Access Compliance Report

Public Rights-of-Way

Intersection ID: 18546	Main Street: MONROE_RD	Cross Street: PINEBOROUGH_RD	Location: SE
ADA ID: 3AC6FEDB07F7	Ramp Type: PerpDiag	Initial Pass/Fail: Fail	Overall Compliance: No
			Severity Score: 13.75

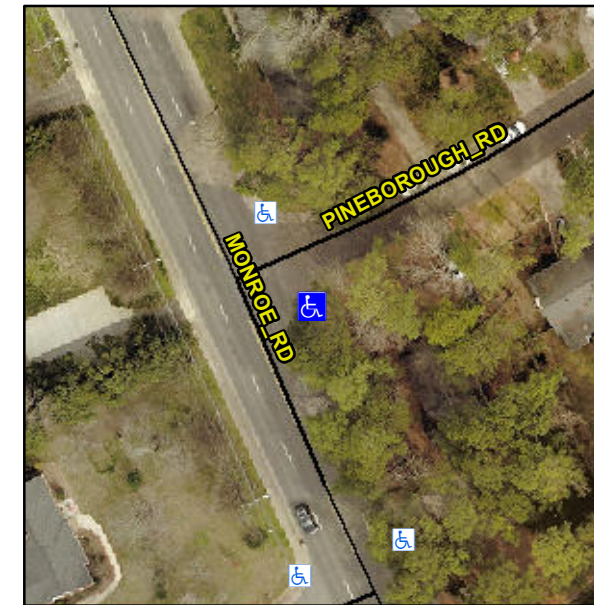
Not Found, R304.2.2, R304.5.3

Compliance	Description	Data	Compliance	Description	Data
N/A	Ramp Length (in)	62.0	No	Ramp Slope (%)	9.0
Yes	Ramp Width (in)	48.0	No	Ramp XSlope (%)	4.5
N/A	Flare Type LT	N/A	N/A	Flare Type RT	N/A
N/A	Flare Slope LT (%)	N/A	N/A	Flare Slope RT (%)	N/A
N/A	Flare Traversable LT?	N/A	N/A	Flare Traversable RT?	N/A
N/A	Landing Length (in)	N/A	N/A	DWS Provided?	N/A
N/A	Landing Width (in)	N/A	N/A	DWS Contrast?	N/A
N/A	Landing Slope (%)	N/A	N/A	DWS Length (in)	N/A
N/A	Landing X Slope (%)	N/A	N/A	DWS Full Width?	N/A
N/A	Landing Curb? (Y/N)	N/A	N/A	DWS Offset (in)	N/A
N/A	Shared Landing?	N/A			
N/A	Gutter Ponding?	N/A	N/A	Gutter Slope (%)	N/A
N/A	Gutter Lip Ht (in)	N/A	N/A	Gutter X Slope (%)	N/A
N/A	Painted X Walk1?	No	N/A	Painted X Walk2?	No
	X Walk 1 Direction	To N		X Walk 2 Direction	To W
N/A	X Walk 1 Width (in)	N/A	N/A	X Walk 2 Width (in)	N/A
	X Walk 1 Slope (%)	2.9		X Walk 2 Slope (%)	2.9
	X Walk 1 X Slope (%)	5.2		X Walk 2 X Slope (%)	1.1

Remove & Replace Curb Ramp With Two New Directional Ramps or Equivalent.
